DOCKETED	
Docket Number:	23-SPPE-01
Project Title:	STACK SVY03A Data Center Campus
TN #:	259547
Document Title:	STACK SVY03A Air Quality Modeling Memo
Description:	N/A
Filer:	Scott Galati
Organization:	DayZenLLC
Submitter Role:	Applicant Representative
Submission Date:	10/15/2024 4:37:27 PM
Docketed Date:	10/15/2024

## Memorandum

### Subject: Revised STACK SVY03A Caterpillar D175 Modeling Summary

Figure 1

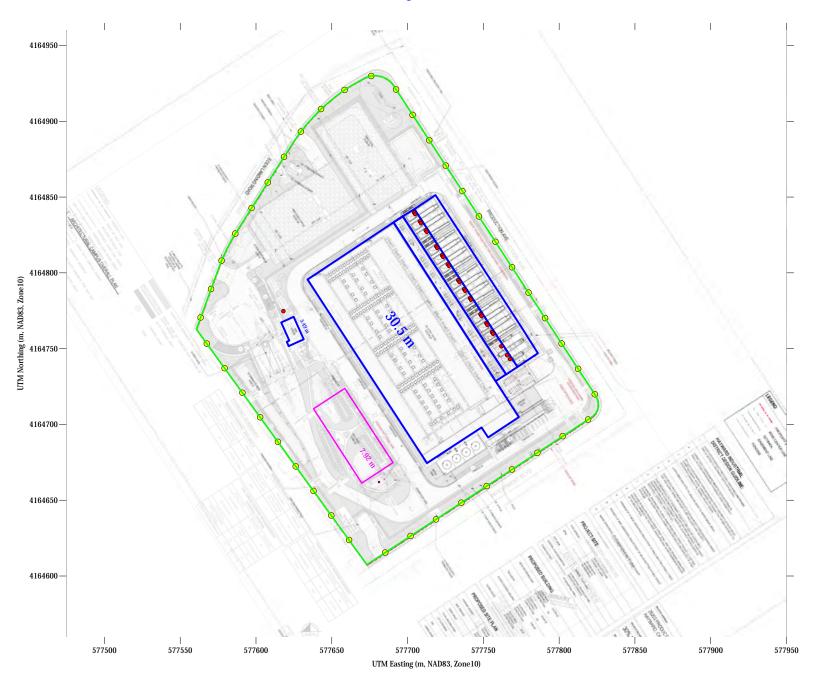
The STACKS SVY03A Data Center Campus is proposing to revise the application by replacing the previously modeled Caterpillar 3512C Tier 4 engine at 2,400 BHP with a smaller Caterpillar D175 Tier 3 diesel engine, rated at 175 BHP. While there will be an emission decrease with the proposed D175 diesel engine, the new proposed engine was modeled to determine if the engine would also result in a decrease in project air quality impacts.

The new proposed engine Caterpillar D175 is shown in Figure 1 along with the replaced Caterpillar 3512C diesel engine. Along with the replacement of engines, the previously existing small data center, called the Ski Lodge, will not be constructed. Instead, a small guard shack is proposed to be located next to the D175 engine.
